TULE SUBBASIN PROBATIONARY HEARING FINAL STAFF REPORT

August 2024

Figure 4-1: GWQ Monitoring Network for the Tule Subbasin
Excerpt from the Tule Subbasin 2022 Coordination Agreement

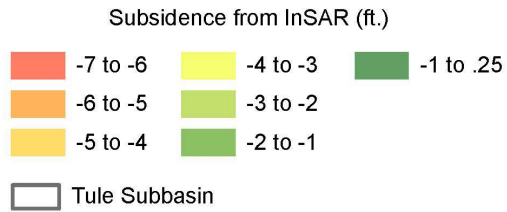
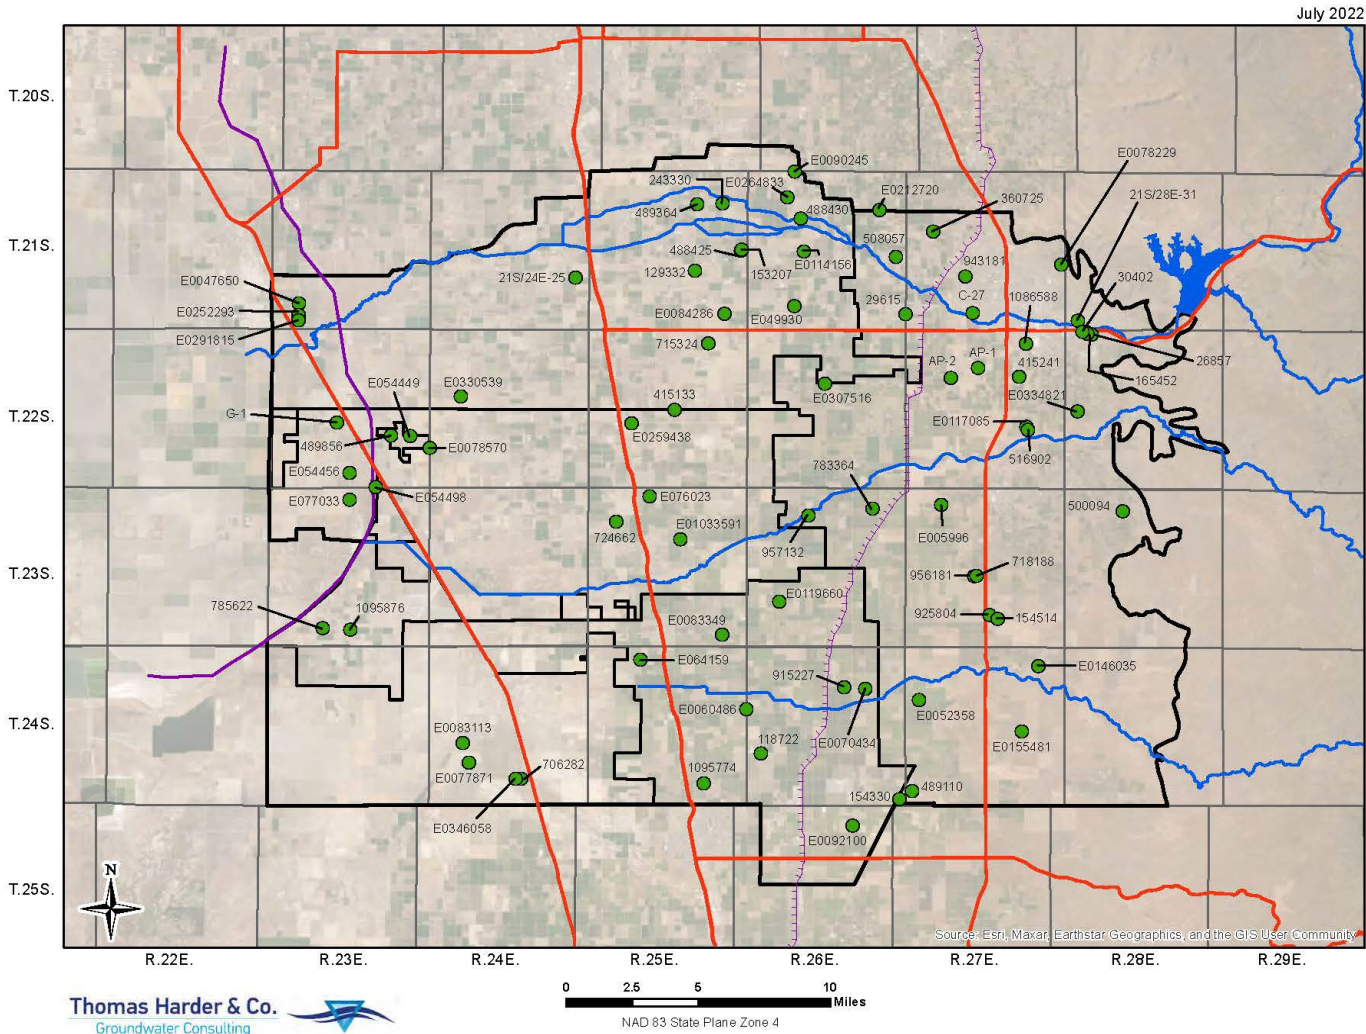
be monitored in the TCWA GSA area, 17 within the LTRID GSA area, 32 within the ETGSA area, 9 within the DEID GSA area, 2 within Alpaugh GSA area, and 5 within the Pixley GSA area (2022 Coordination Agreement, Attachment 1, Figure A1-6). Although these RMS are listed in the coordination agreement, the construction and source of many of the wells is unknown and not defined or specified in each of the GSPs. Additionally, IM, MOs, and MTs have not been established for the majority of these proposed RMS locations.

It is unclear how the RMS defined in the 2022 Coordination Agreement correlate to RMS defined in GSPs. The Tule Subbasin Coordination Agreement includes Figure A1-6, which is a map of 76 RMS wells for degradation of groundwater quality. The GSPs define 26 RMS, primarily in tables. It is therefore unclear:
